**NOTICE OF PREPARATION OF A  
DRAFT ENVIRONMENTAL IMPACT REPORT FOR THE  
NATIONAL CITY CARMAX AND HOTEL PROJECT**

**Project Title:** National City CarMax and Hotel Project

**Subject: Comments on the Notice of Preparation of a Draft Environmental Impact Report for the National City CarMax and Hotel Project SCH# 2016111035**

Subject: RESPONSE TO NOTICE OF PREPARATION OF A DRAFT  
ENVIRONMENTAL IMPACT REPORT  
NATIONAL CITY CAR-MAX AND HOTEL PROJECT  
SWA FILE: (DEV) CAR-MAX

## National City Car-Max and Hotel Project Existing Easement and Water Facilities

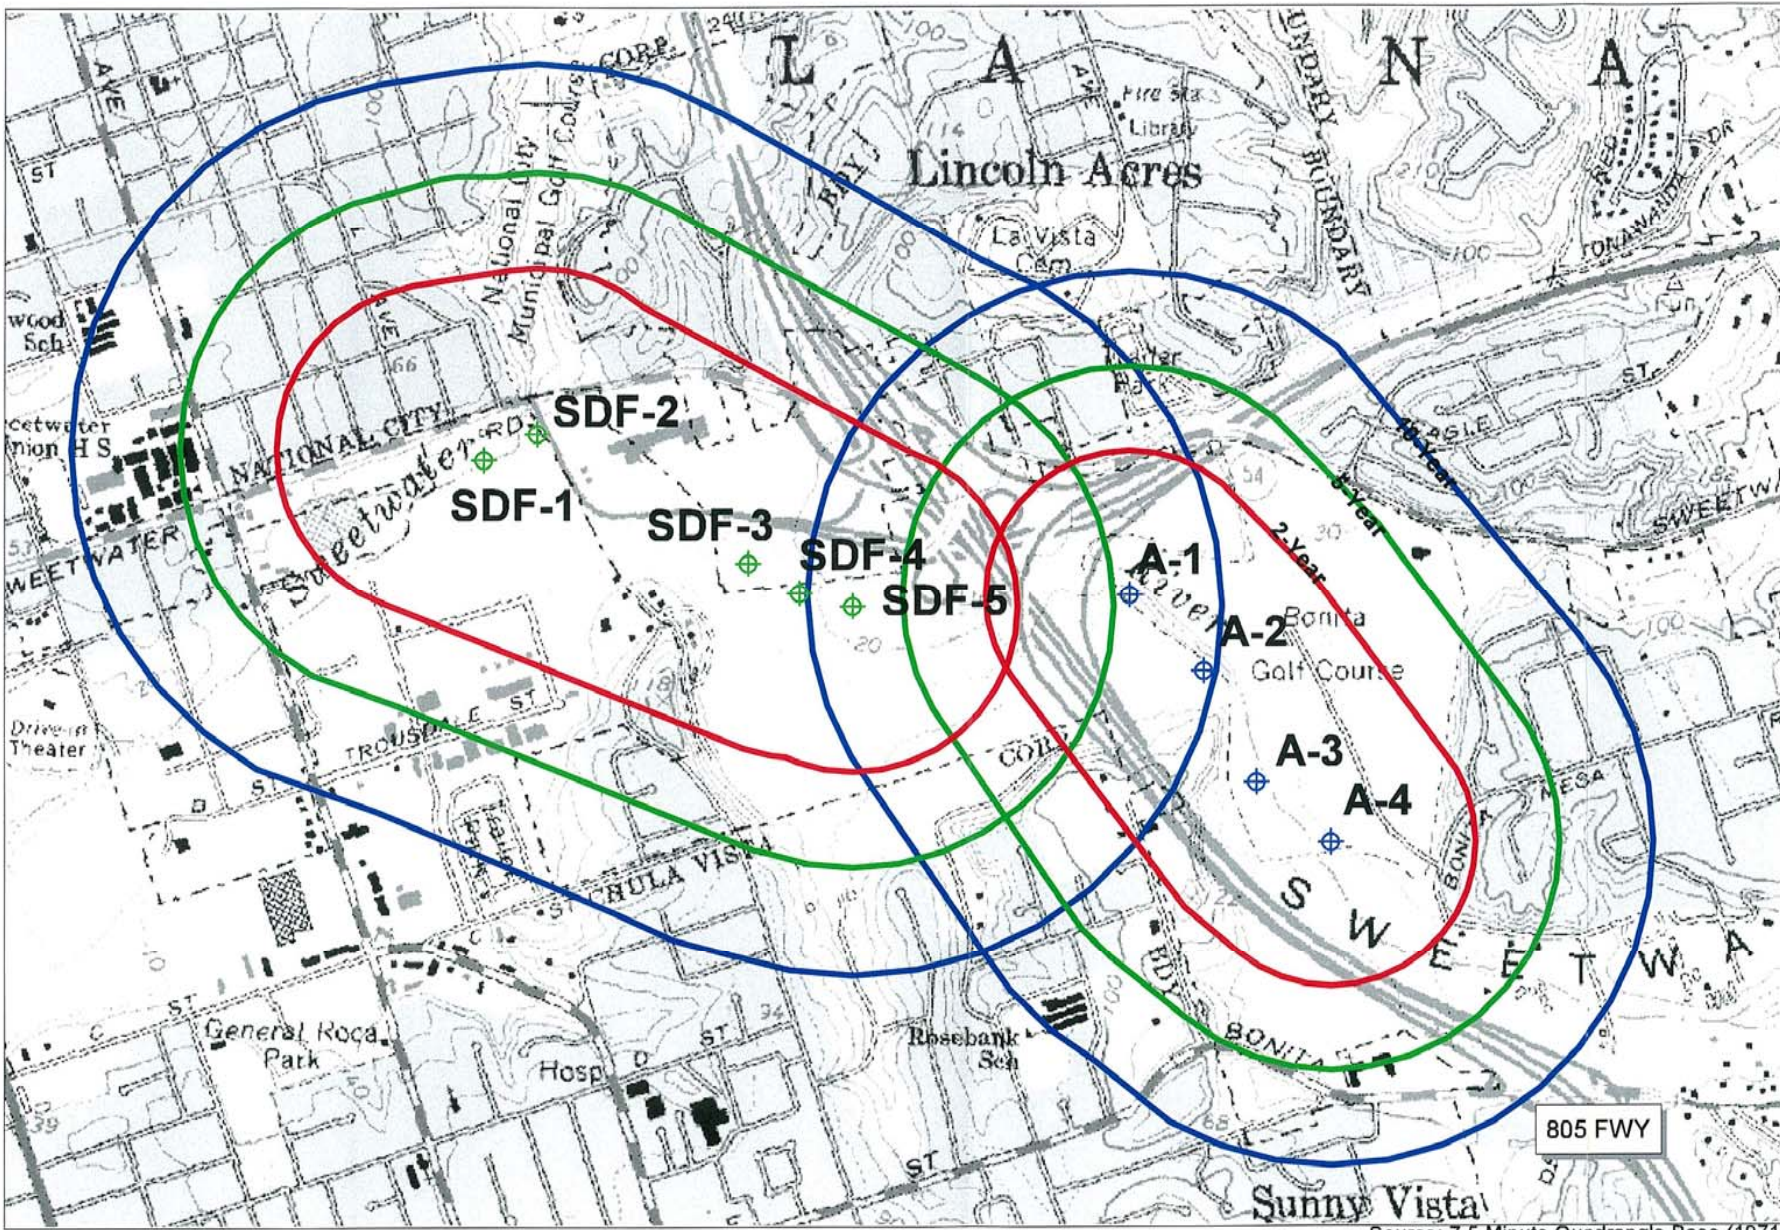
Sweetwater Authority (Authority) has received a Notice of Preparation (NOP) of a Draft Environmental Impact Report (DEIR) for the above-referenced project, within the City of National City. It is understood that the project is on a 15.08 acre site near the southeast corner of the Interstate 805 and State Route 54 interchange, and will involve the construction of an automobile dealership, grading to accommodate a potential future hotel, and re-contouring of the unnamed tributary over the subject parcel. It is further understood that the project will require General Plan, Zoning, and Land Use Code amendments to allow for the proposed uses. It is to be noted that the Authority owns and operates an 18-inch welded steel water transmission main located within a 30-foot wide easement over the subject parcel, as shown on the enclosed Exhibit A.
